ANEFCO INC.

Subject : Amendment to COC 9071
Docket No. 71-9071

In response to your letter dated July 12, 1985, we have addressed your ten questions with regards to sections 10CFR 71.47 and 71.51(a)(2) and have included drawings of the shield assembly and shoring.

SK 402

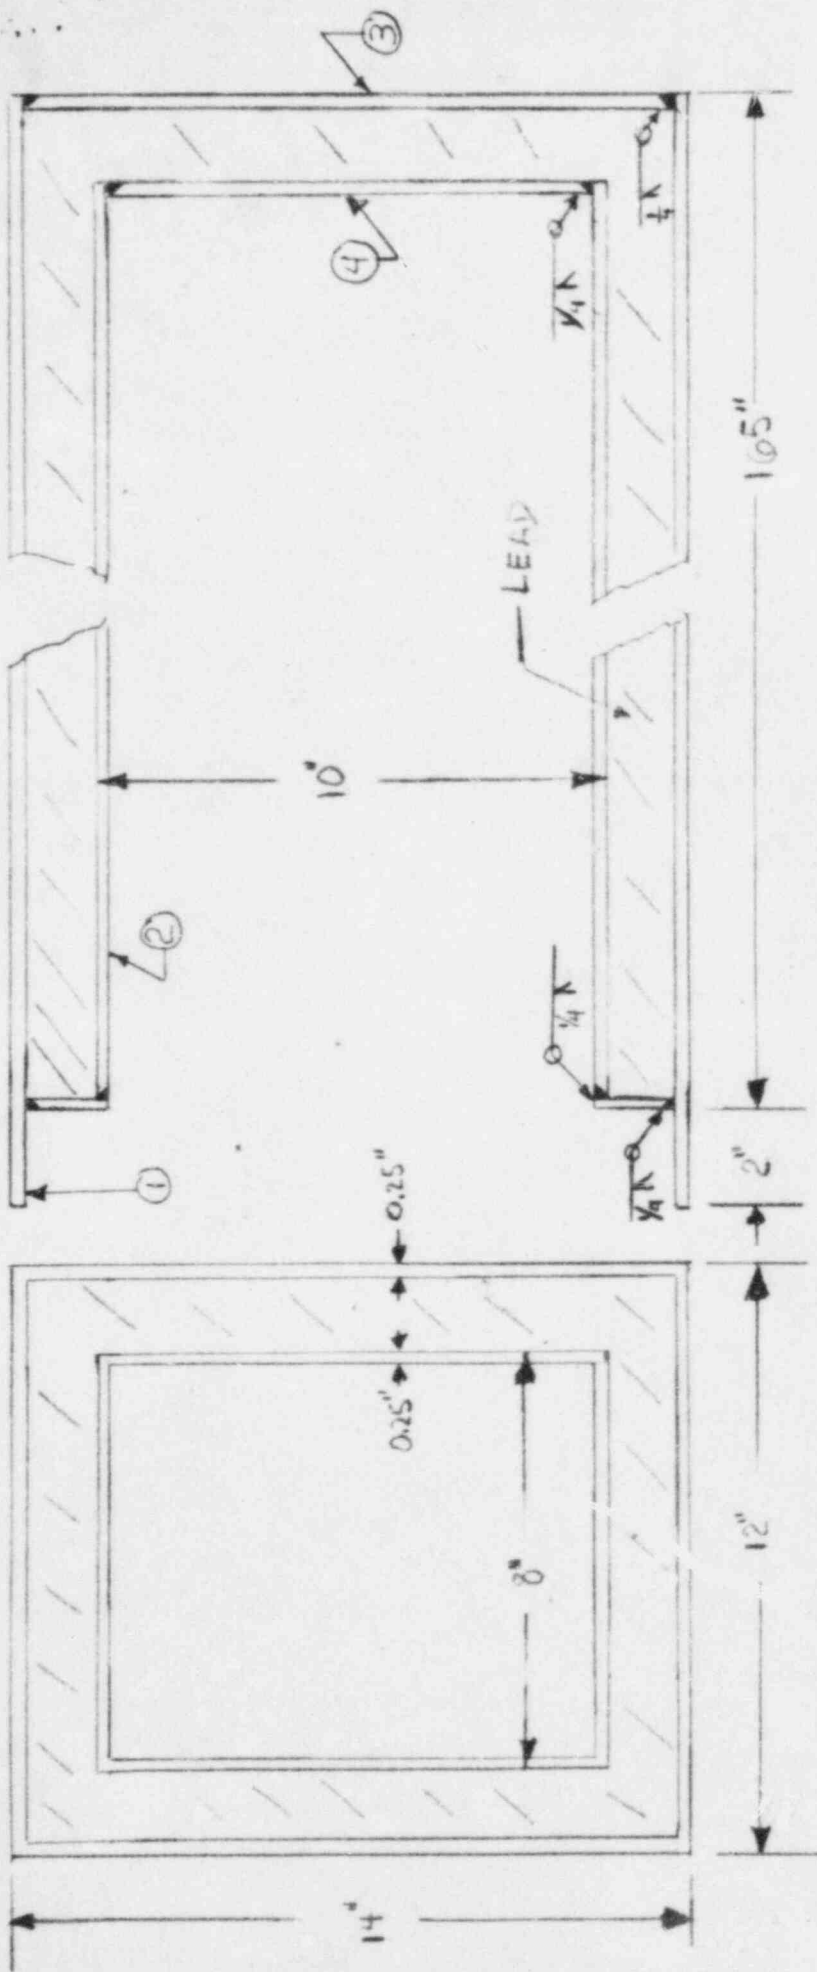
SHORING FOR HP 101 INTERNAL SHIELD
